Gutter/Filter & Miscellaneous Operation & Maintenance Manual

Bill To	To	Project Manager
Lindsey	Spear Corporation	Sam
Spear Corporation 12966 N	Blake sblake@spearcorp.com	Daniel
CR 50 W	Grundlock dgrundlock@spearcorp.com	
Roachdale IN 46172		Virginia Collins
United States		virginia.collins@paddockindustries.com
		803-372-6067

PO #
Connersville HS PO36545

Submitted ID: 131113-1

CONCENTRIC REDUCERS

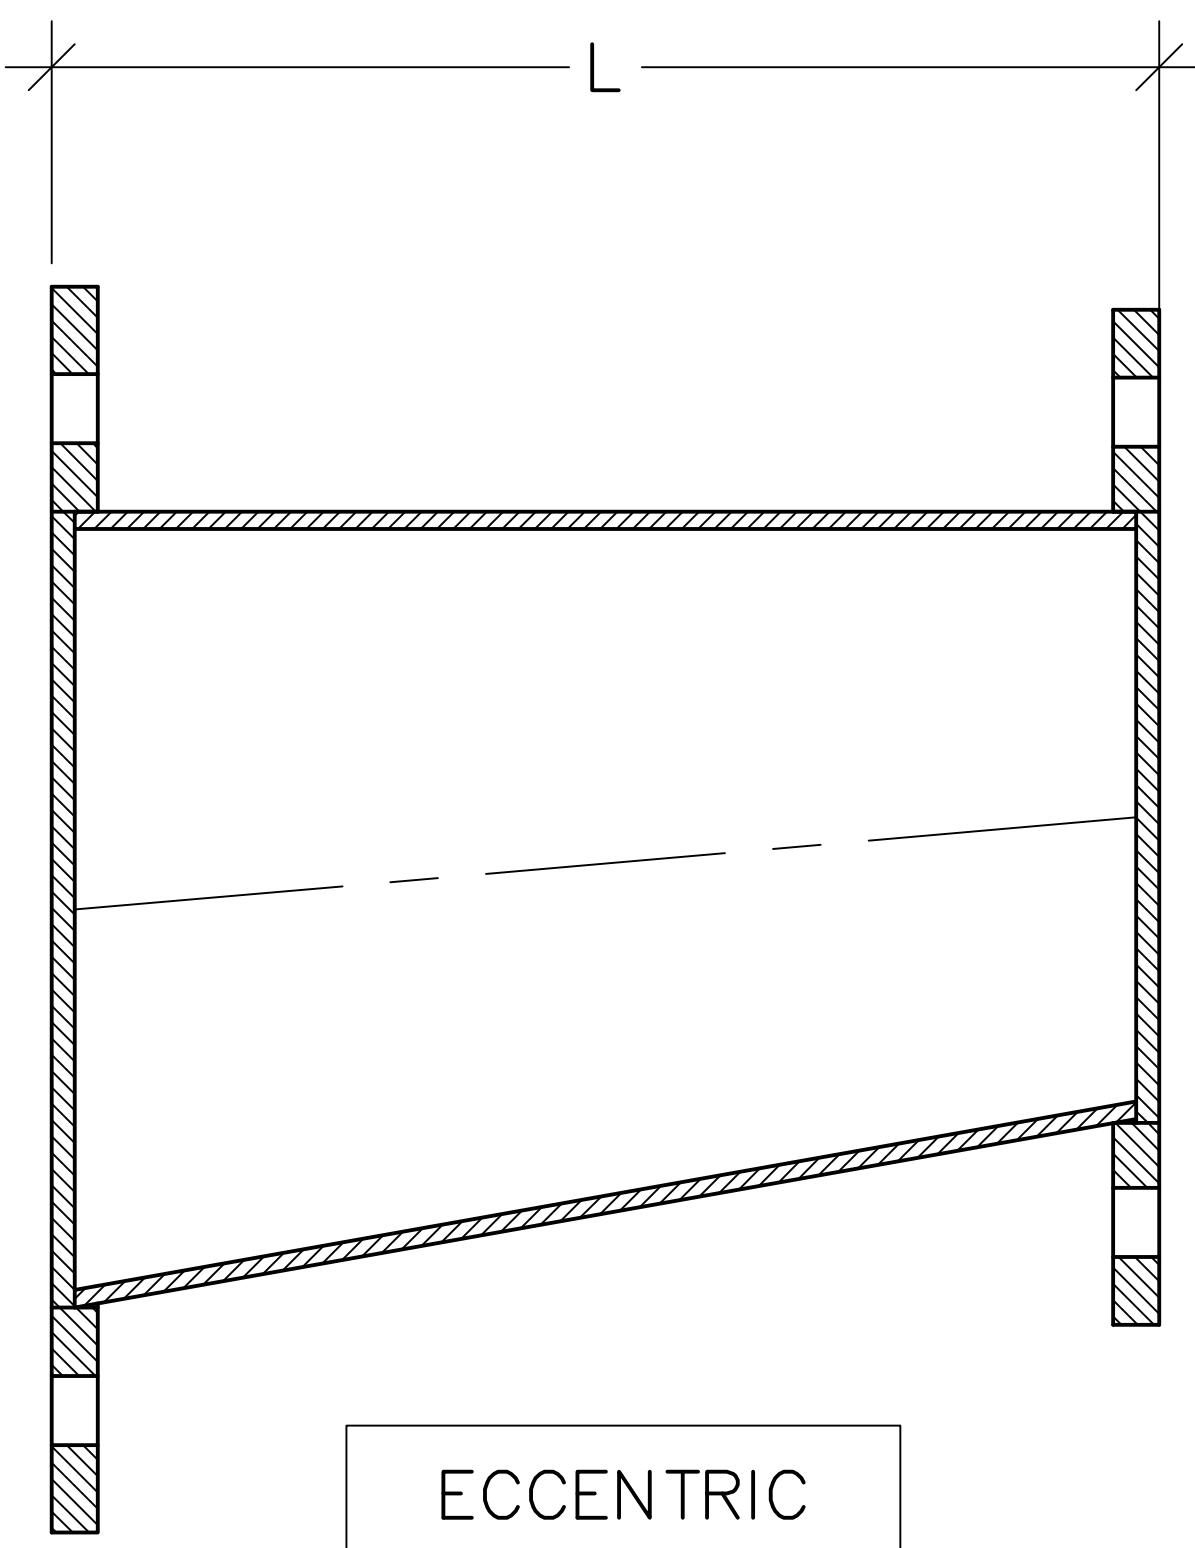
Exceptions as Noted:
This strainer size seems too large, connection between strainer and pump is 8" to 4".
Contractor to verify size is correct.
